HERTSMERE BOROUGH COUNCIL
ELSTREE WAY CORRIDOR AREA ACTION PLAN DPD
STATEMENT OF COMMON GROUND BETWEEN

HERTFORDSHIRE COUNTY COUNCIL HIGHWAYS SERVICE (HCC)

VERSION 1
22ND JULY 2014

New figure 3:

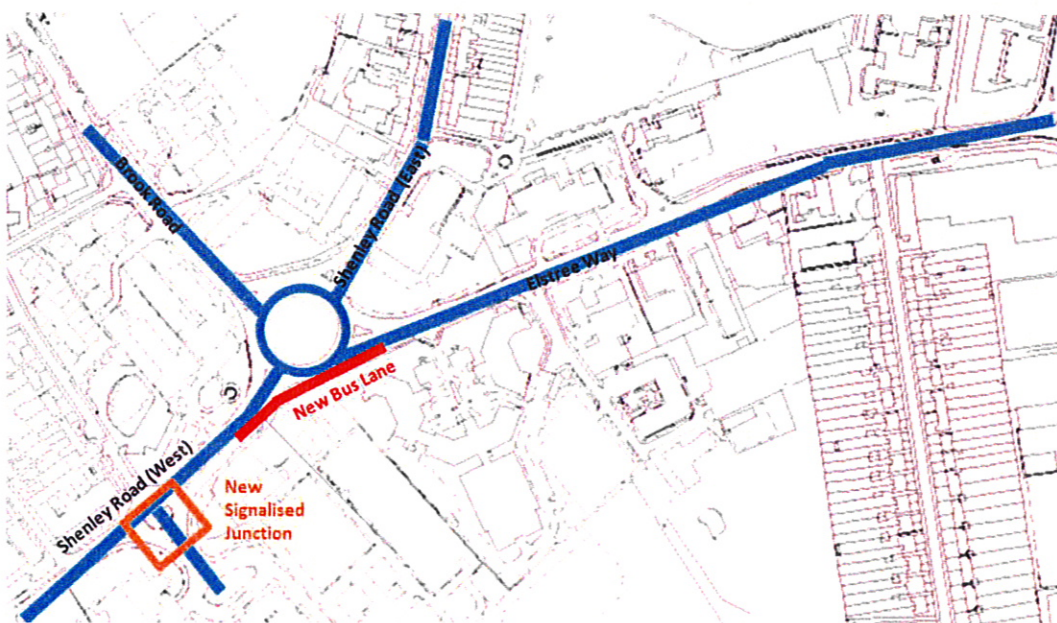
In order to further improve the operation of the highway layout a revised scheme has been produced (DOC34). It is agreed that this general arrangement drawing will meet the objectives of the EWCAAP in terms of sustainable transport provision and enabling modal shift subject to the associated phasing, traffic management and travel planning measures being delivered as the sites are developed. Final testing of the delivery options will be required to be completed prior to the examination of the EWCAAP. Governance arrangements, delivery mechanisms and associated risk analysis will be agreed between HBC and HCC prior to the examination of the EWCAAP - as part of HBC's emerging 'Developer Contributions Framework.

Deletion of Figure 3: Highways Works
